# NR001 & NR002

- **Summary of QC findings**
- Visual inspection
- Optical inspection
- RF measurements
- CMM measurements

# Cavity TB9NR001. HOM couplers notch frequency measurements.

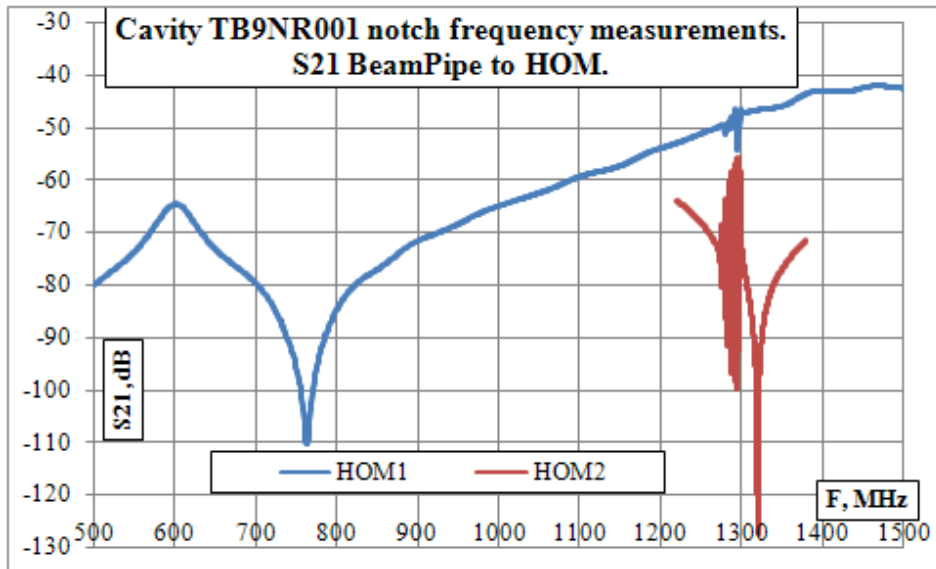
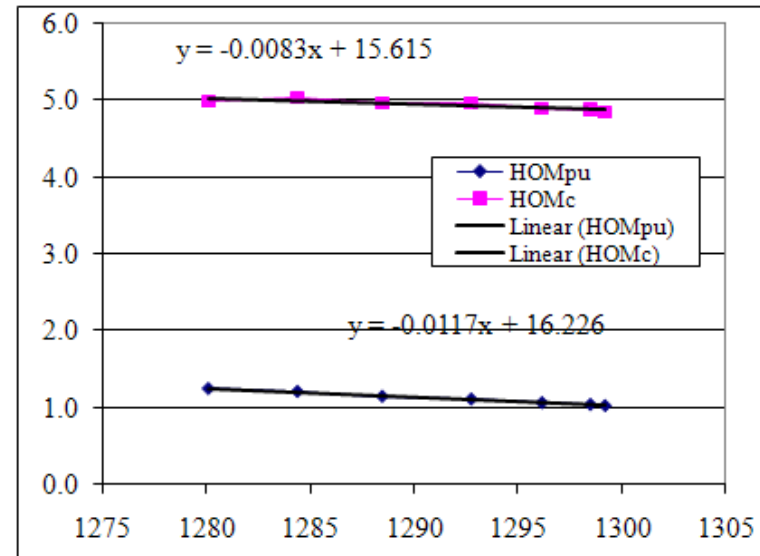
HOM1 notch frequency ~500 MHz lower than design.

Cavity TB9NR001 HOM1 (HOMc) tuning test. 0.5 mm deformation of tuning gap changed notch frequency only by 45 MHz.

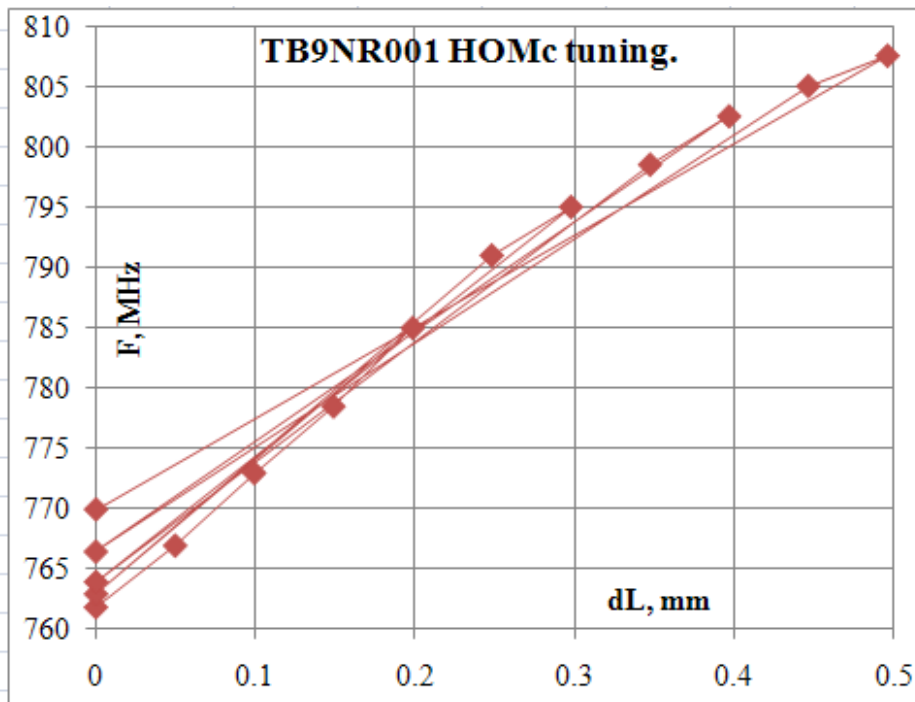
It means that **HOM1** of this cavity can not be tuned safely by usual tuning technique.

- HOM notch frequencies shall be measured and adjusted prior to welding the end groups. The position of the formteil should be monitored and measured after welding.

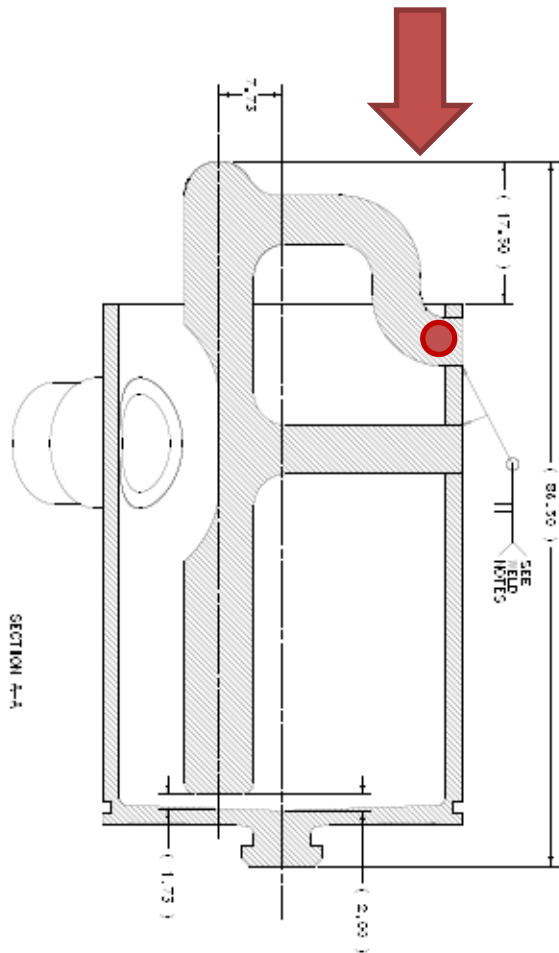
The optical images are not able to show the weld of the near leg of the formteil to the HOM can, this is an indication that the formteil "S" is in the way.

# Position of equator welds relative to cavity axis

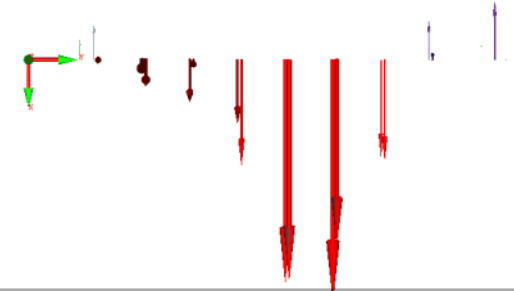
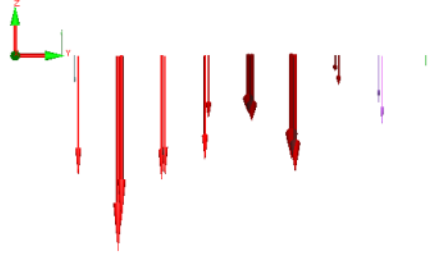
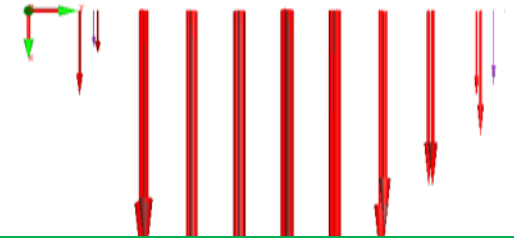
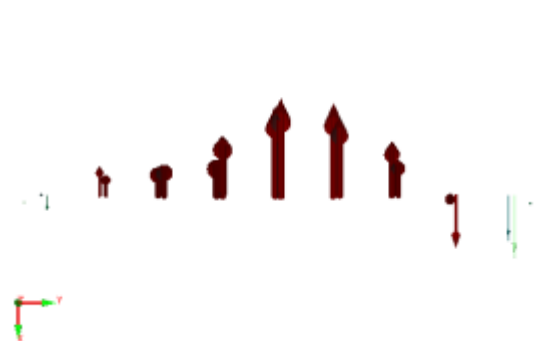
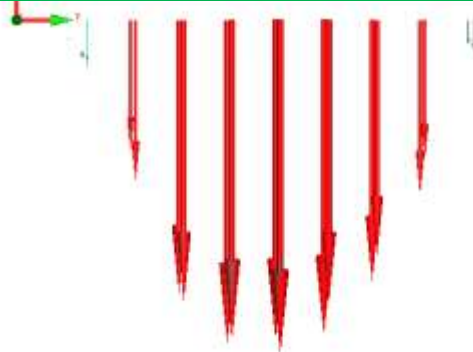
- NR001 is 3.373 mm longer than nominal
- NR002 is 2.710 mm longer than nominal
- Perpendicularity of end flanges from cavity axis is off by  $\sim 0.2$  degrees
- Equator diameters of both cavities are 0.4-0.6 mm larger than normal
- Equators are 0.2-0.5 mm out of round more than normal
- Positions of equators relative to cavity axis are atypical (see next slide)

- The weldment of the end groups to the dumbbell assembly must be studied and representative samples shall be made to qualify this joint.
- The fixturing of the end groups during the final welding should be improved to guarantee a better perpendicularity relative to the cavity axis.
